Applicant : Sadakierski et al

Serial No.: 10/808,163

Amendments to the Drawings

Remarks

Annotated Sheet Showing Changes

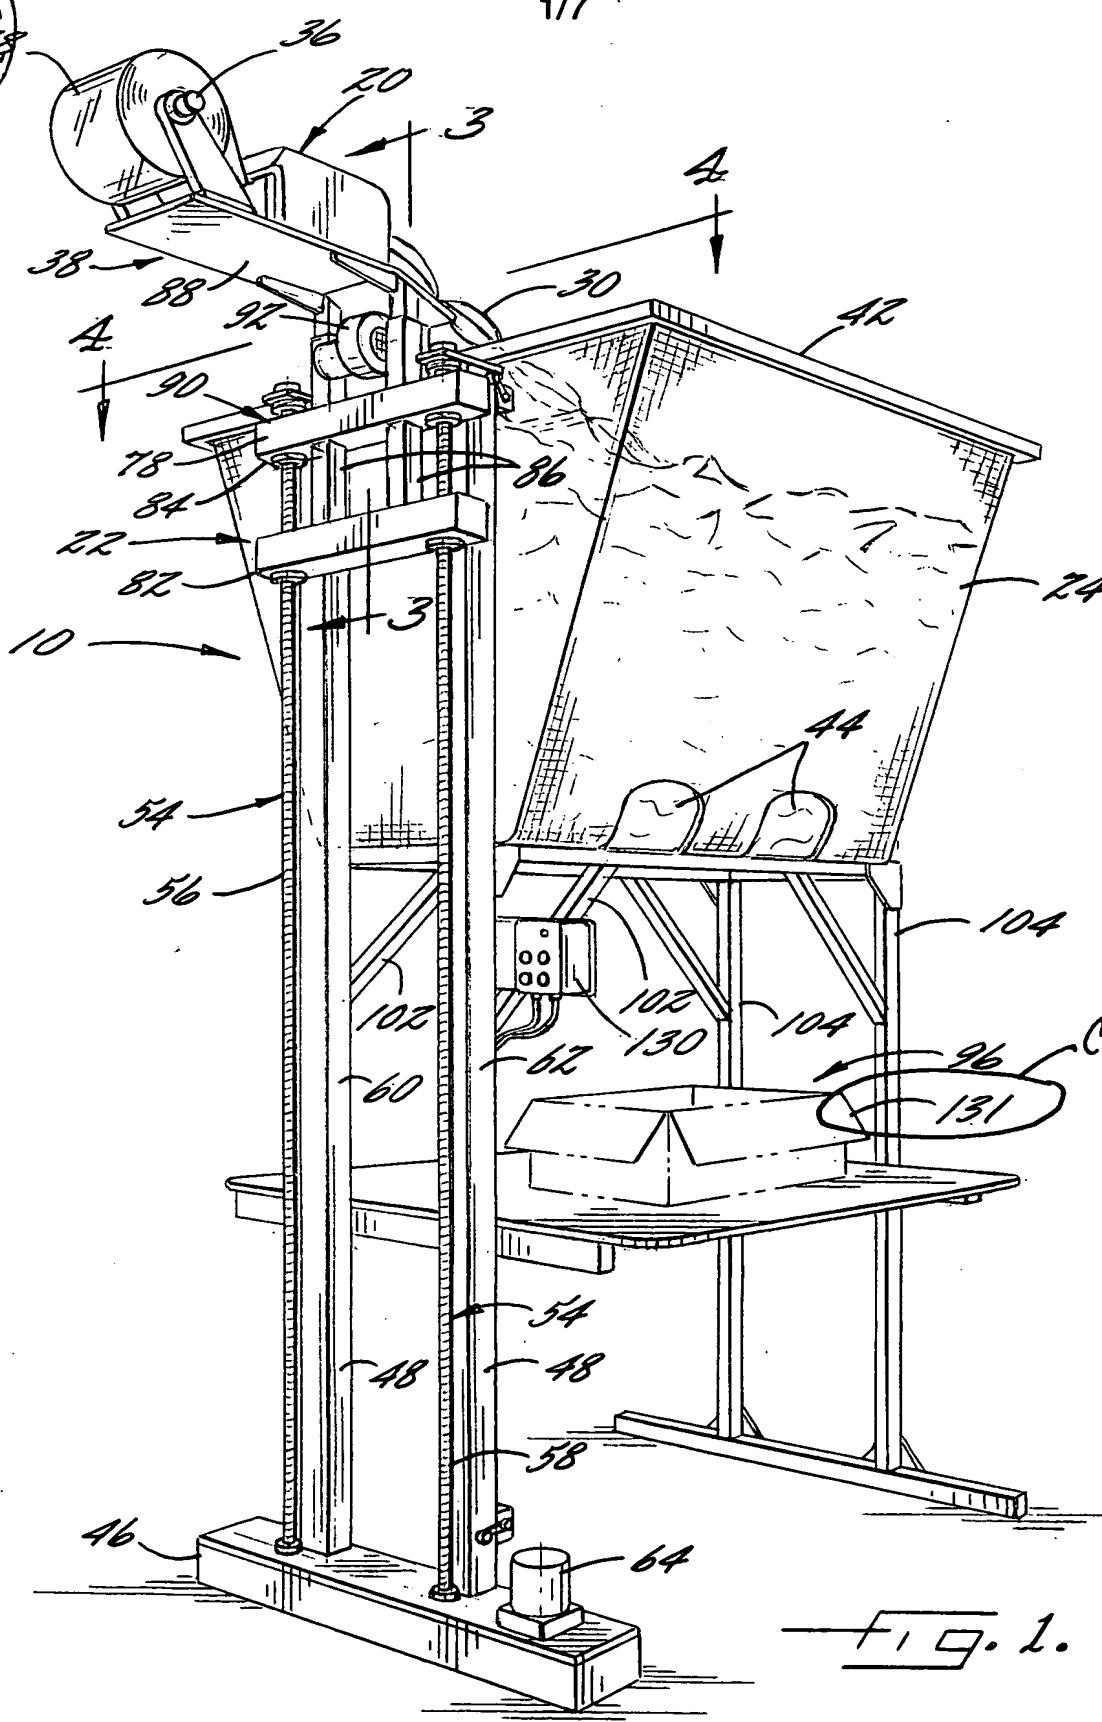
The attached sheets 1 and 5 of the formal drawings includes changes to Figures 1 and 7. Sheet 1 replaces the original sheet 1; Sheet 5 replaces the original sheet 5. Figures 1 and 7 are amended to change the numbering of the box from 130 to 131 to avoid duplicate numbering.
